June 25, 2019

RE: Comments on Low Activity Waste Pretreatment System, Proposed Construction and Operations of New Waste Storage and Treatment Unit, Class 3 Modification to the Hanford Facility Dangerous Waste Permit

On behalf of Hanford Challenge, I am submitting these comments in response to the LAWPS Class 3 Modification to the Dangerous Waste Permit at the Hanford nuclear site.

Figure 5-5. Unmitigated Vulnerabilities Identified for Radiological Control and Industrial Safety and Hygiene.

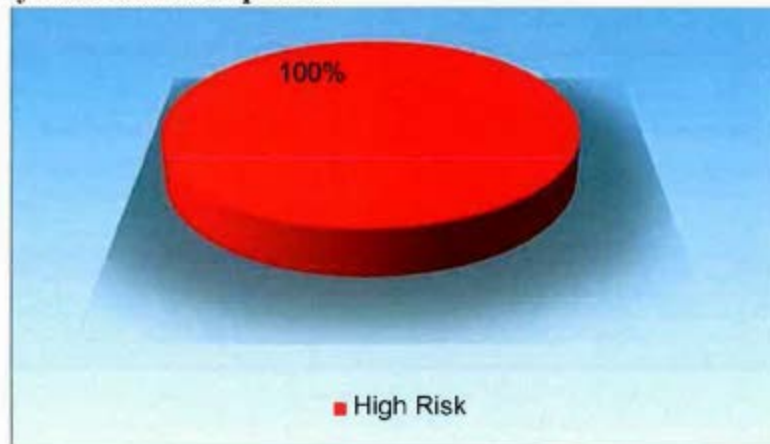
A total of eight (8) vulnerabilities were identified for the radiological control and industrial safety review area. Figure 5-5 shows that the vulnerabilities identified for the system were all considered high impact for which mitigation is recommended prior to cold commissioning and preferably prior to startup testing.

The review team identified specific issues with the radiological control approach all of which will require correction prior to startup testing. Listed below are summarized vulnerabilities:
